PRODUCT CHANGE NOTICE

PCN#11-015

HXG-122+, HXG-242+

HXG-122+ and HXG-242+ footprint compatibility Original vs. New

Photos: Original and New Case Styles

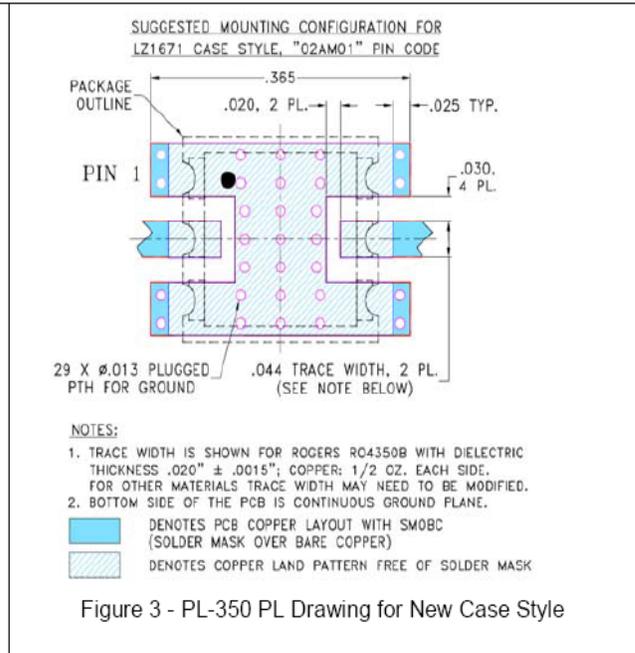
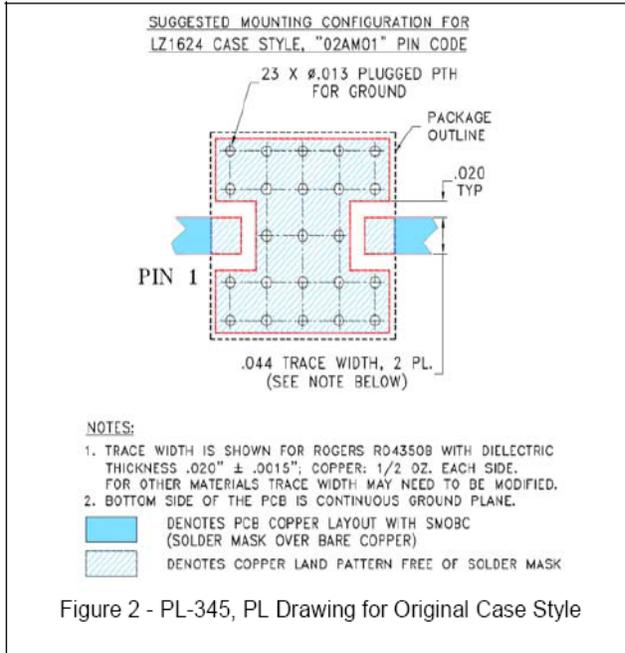
The initial released outline is being upgraded to include castellated leads and wrap-around terminations for signal and ground, enabling inspection of the solder attachment through visible solder fillet. The upgraded version also be based upon a PCB base with ceramic cover, and will be offered in a new outline drawing.

Figure 4 - Existing Outline Drawing (LZ-1624)

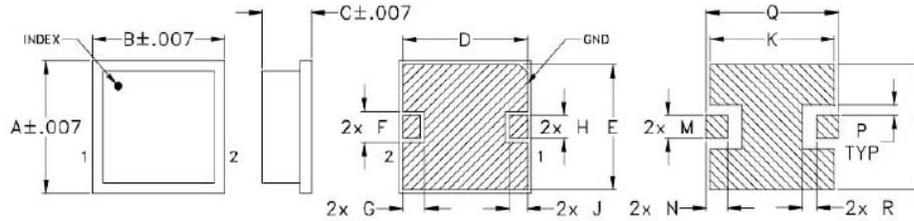
- Change package from bottom-side-only soldering to castellated wrap-around terminations
- Case style change from LZ1624 to LZ1671
- Carrier tape orientation per TR-F78, compliant to EIA 481

Appendix 1 - Assessment of Original Case Style unit mounted on New PCB Land Pattern

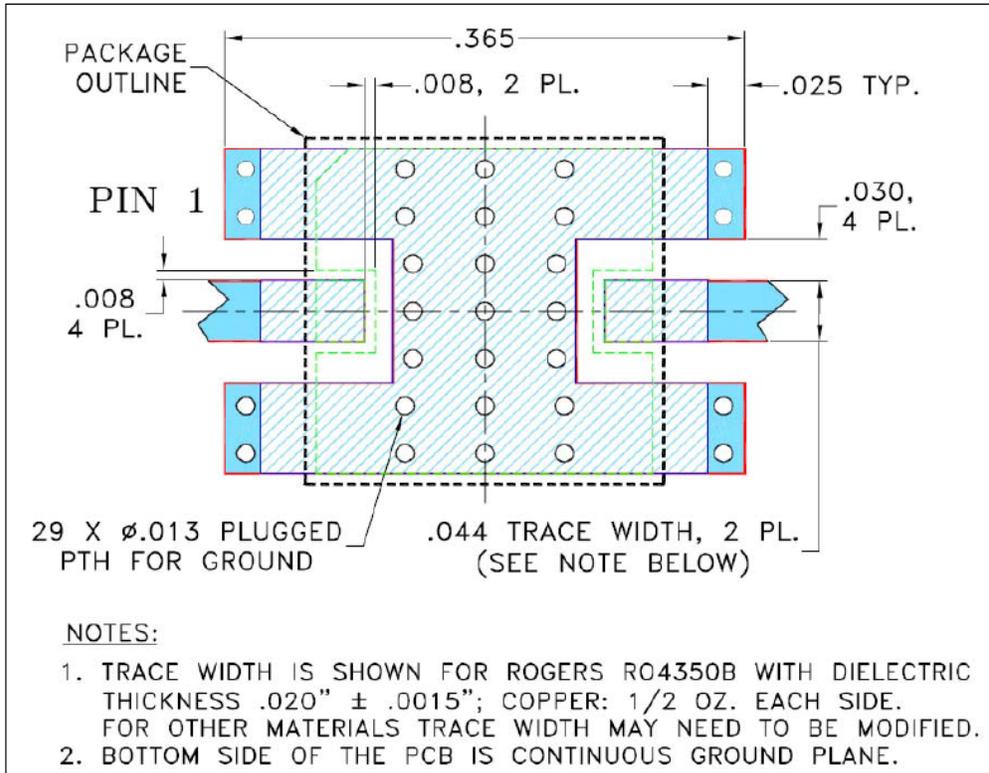
Both case styles may be used with the alternate PCB Layout's; however, in the case of the *new* Case Style (LZ1671) used with the *original* PCB Layout (PL-345), a solder fillet will not be observable at the castellated leads. (See Appendix 1 and Appendix 2 for detailed assessments)
